ADDENDUM NO.: 2

DATE OF ADDENDUM: JUNE 2, 2015

**JOYNER HALL
NORTHWESTERN CONNECTICUT COMMUNITY COLLEGE
BI – CTC – 427**

REVISED SECTION 1/A-501.1

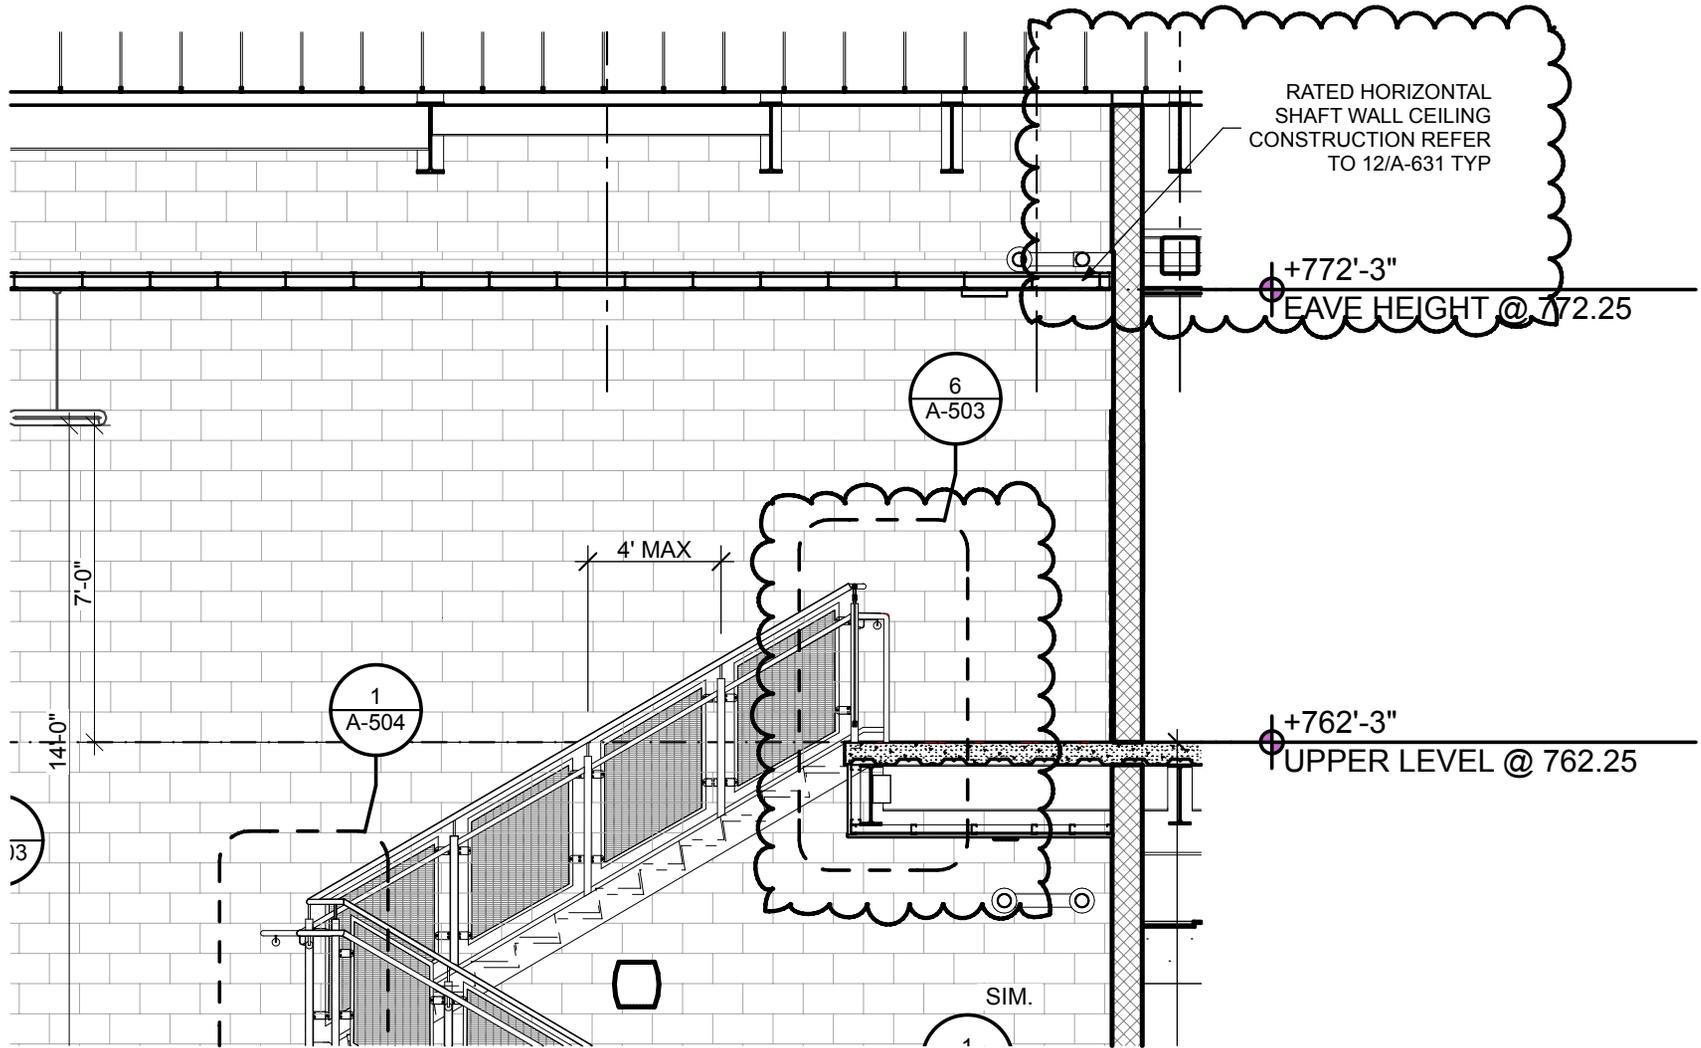
Clarification: Drawing A-501.1 handrail dimensions corrected on detail 1. Refer to ADA-41 attached to this addendum.

REVISED DETAIL 1/A-620

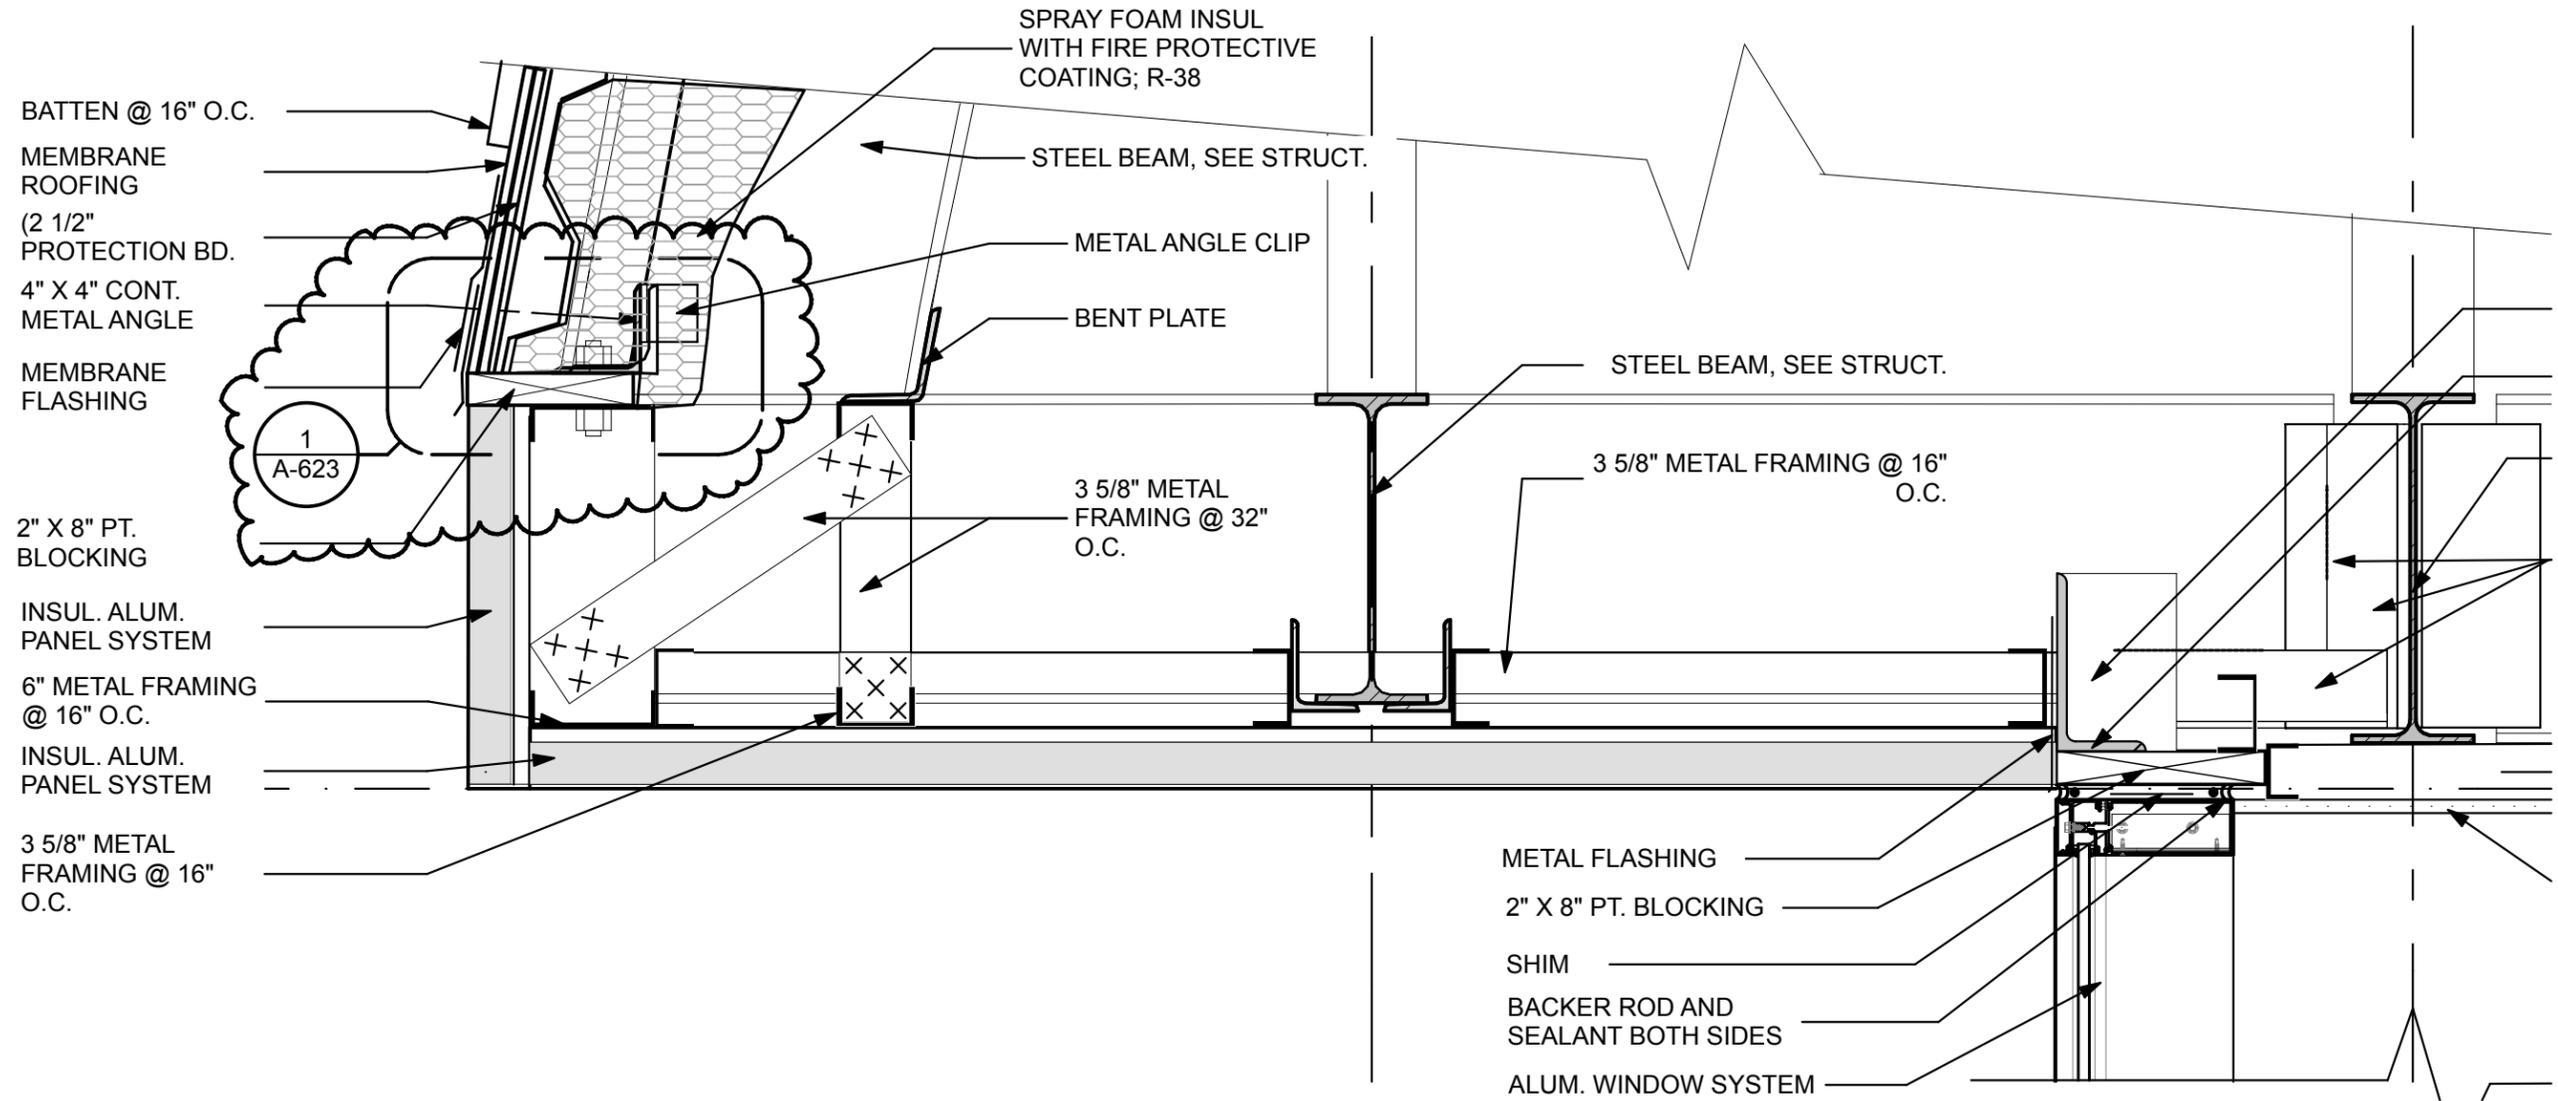
Clarification: Detail bubble referring to typical detail 1/A-623 has been added to detail 1,3,4&6/A-620 to note the drip edge. Refer to ADA-24, ADA-49, ADA-50 and ADA-51 attached to this addendum.

REVISED DETAIL 2/A-621

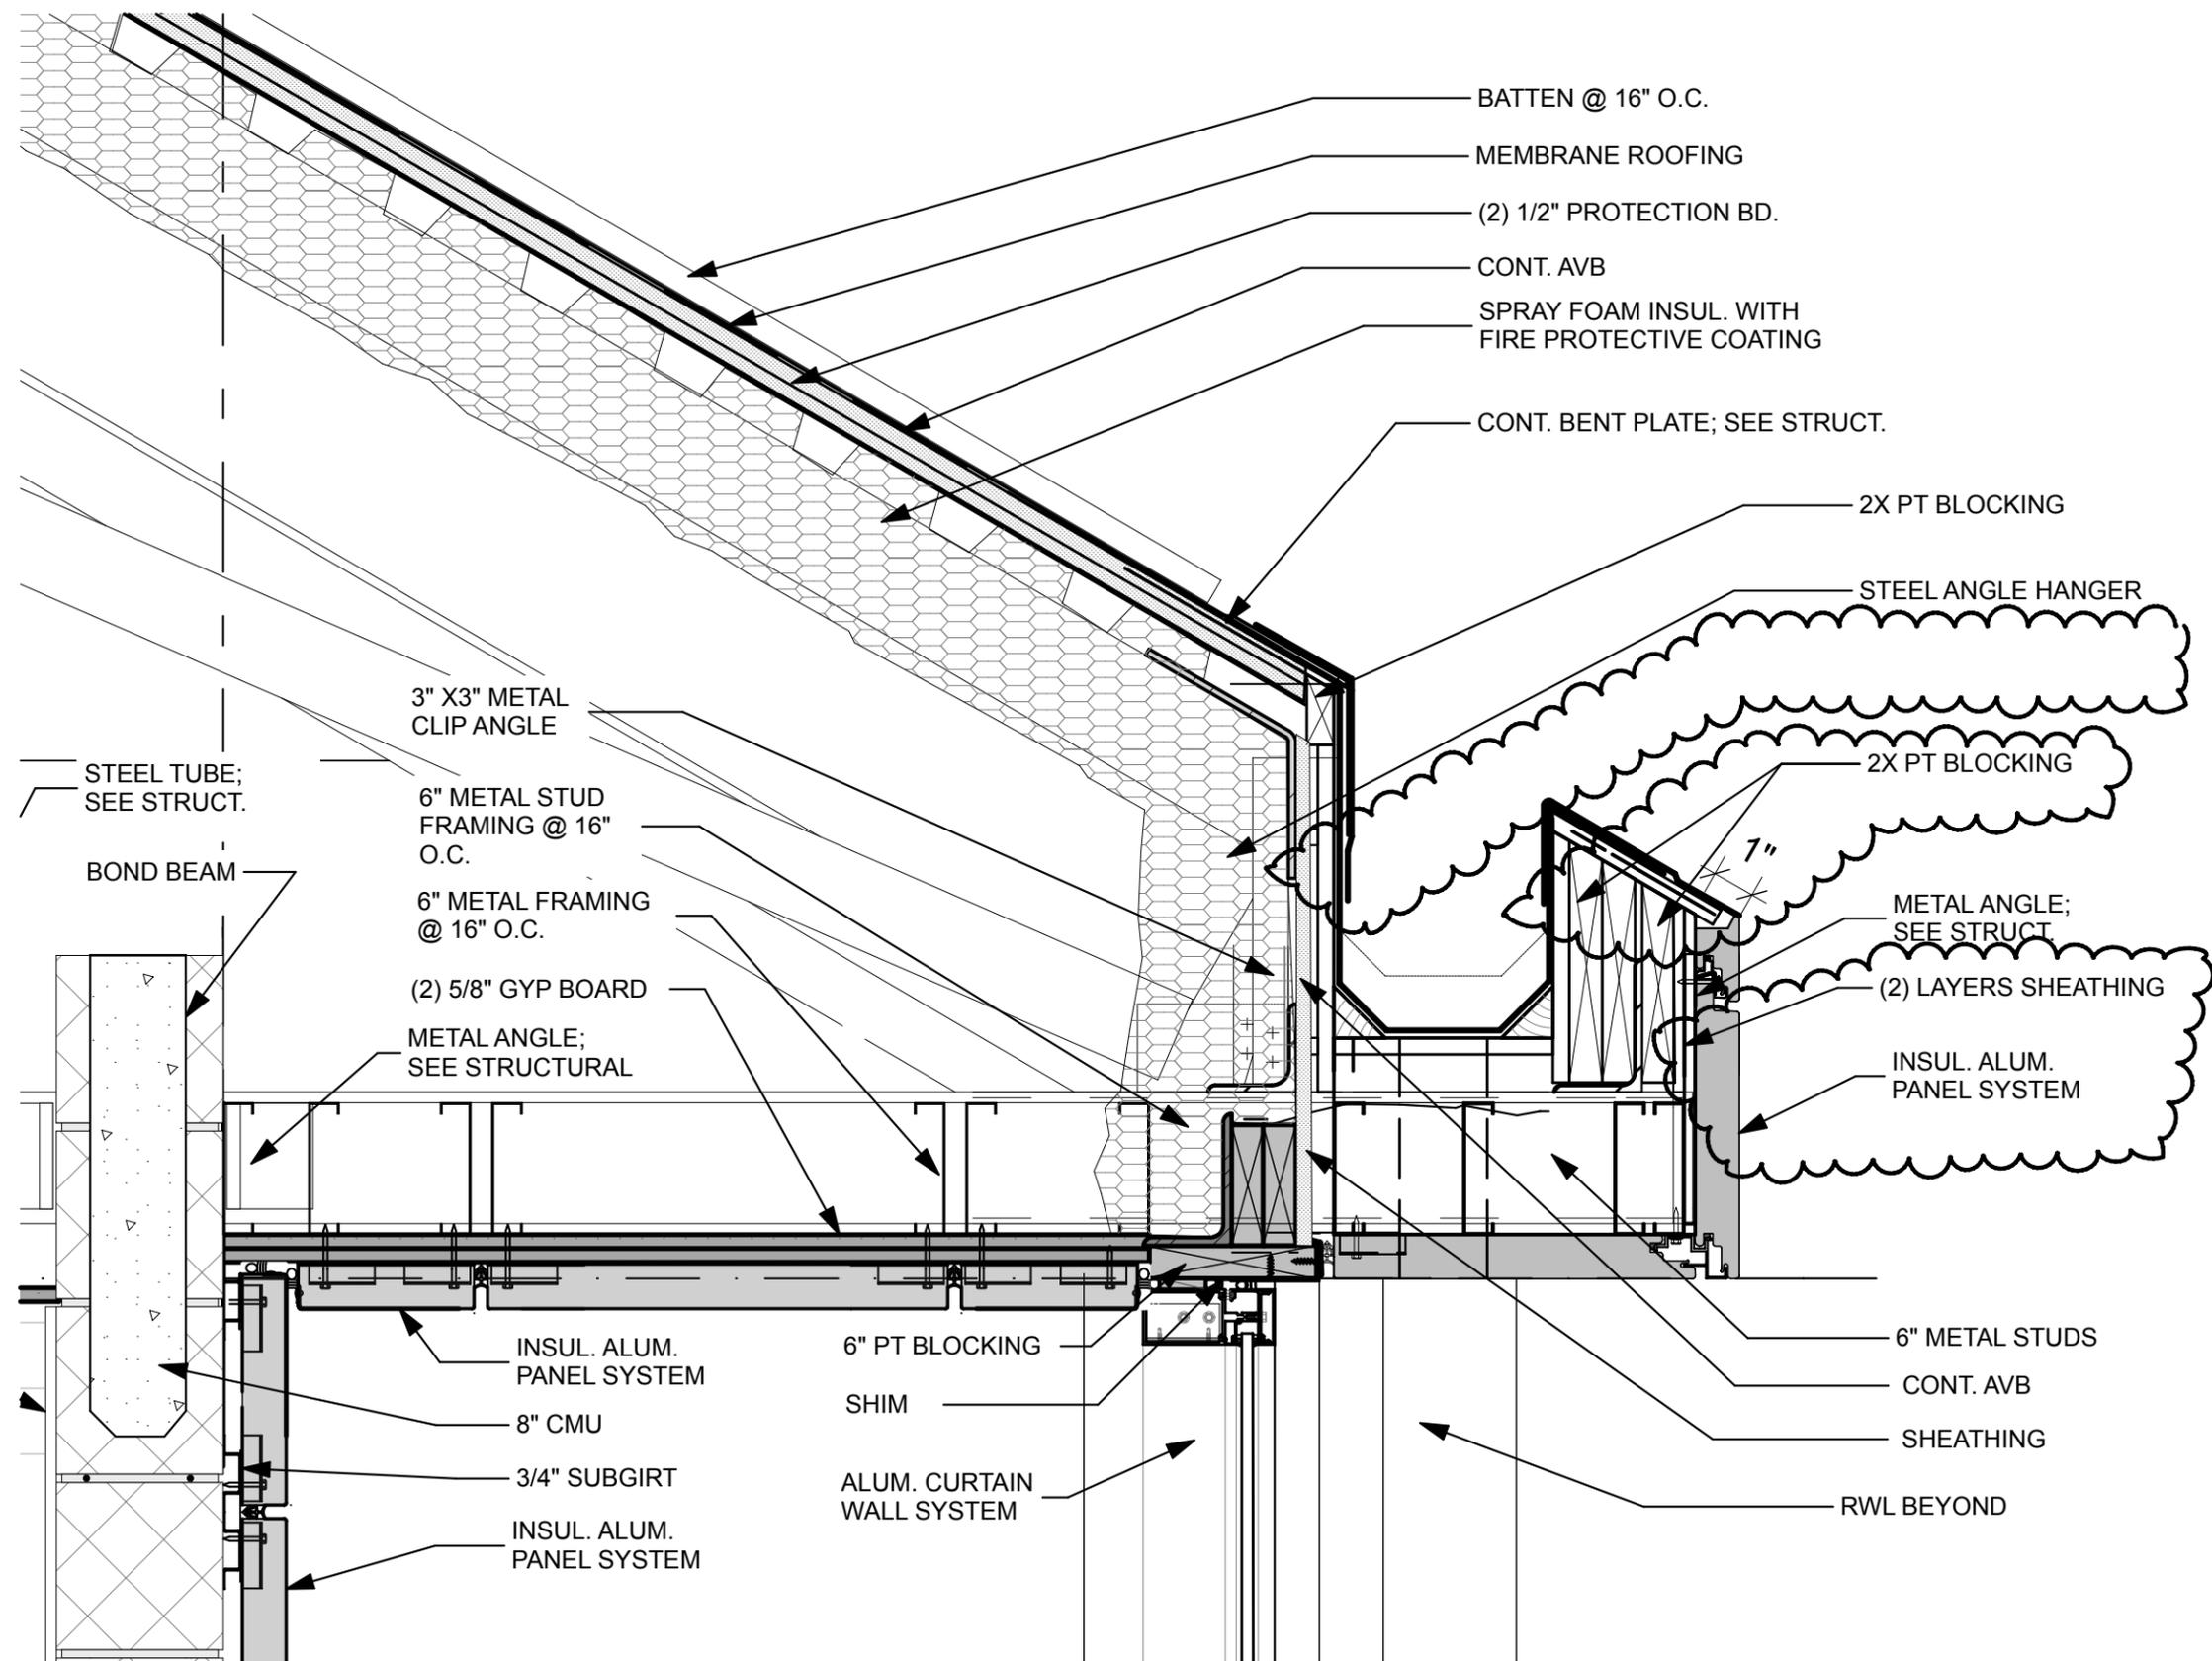
Clarification: Detail 2/A-621 Built-in gutter is 10" typical as showed on 1 & 3/A-621.

HOT WATER PIPING RISER DIAGRAM
NOT TO SCALE

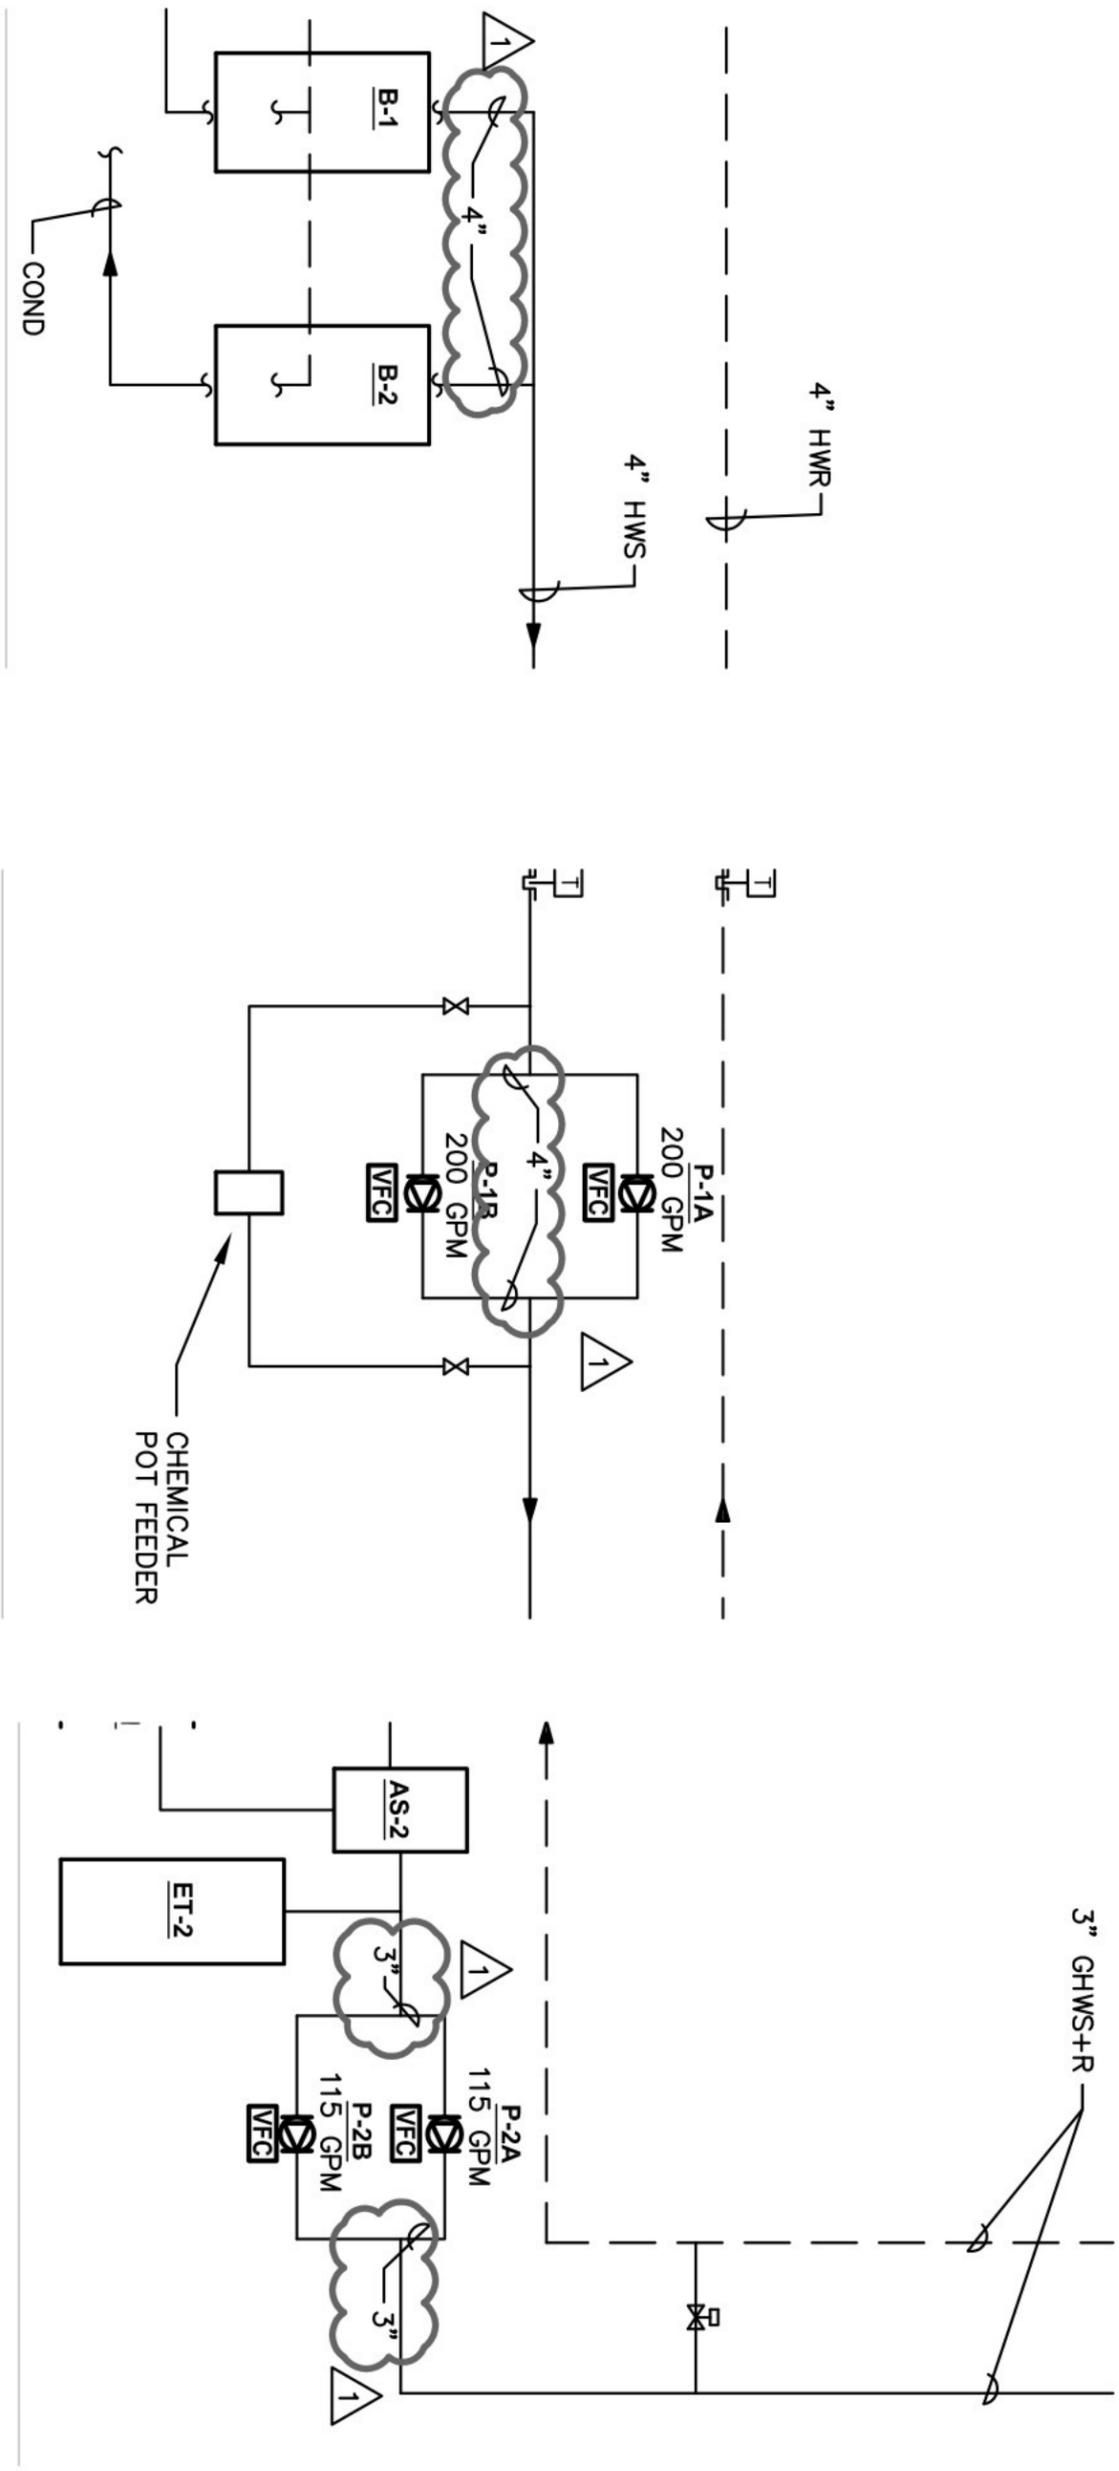
Clarification: Added pipe sizes for boiler and pump connections. Refer to sketch ADH-01 attached to this addendum.
